Master Plan Amendment #2013-0002

Development Special Use Permit # 2012-0028

Park Meridian – Eisenhower East Block 19

2250 Mill Road

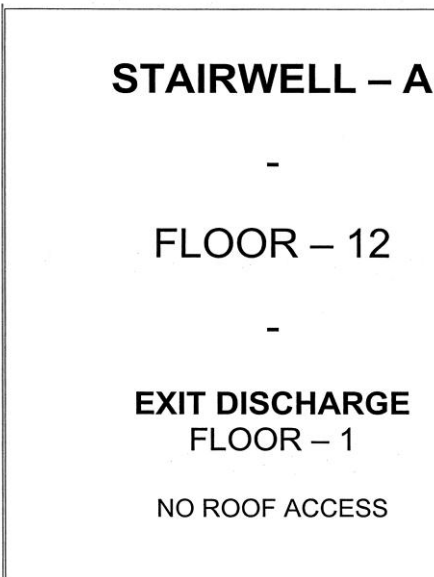
- **Turning Radius – Wall to Wall = 54.98 feet + / – 2 feet**
Curb to Curb = 51.33 feet + / - 2 feet
Inside turning radius = 37.73 feet + / - 2 feet
- **Overall Length – 47' – 4 ½"**
- **Overall Width – 98"**
- **Wheel Bases from front axle to both rear axles – 240"**
- **Tandem axle spacing – 56" CL of axle to CL of axle**
- **Gross Weight – As built with no equipment or water gross weight = 66,000#**
- **Angle of Approach – 13 Degrees**
- **Angle of Departure – 11 degrees**
- **Ramp Break Over – Break over angle is 9°**

Applicant has demonstrated turning radius for Tower 203.
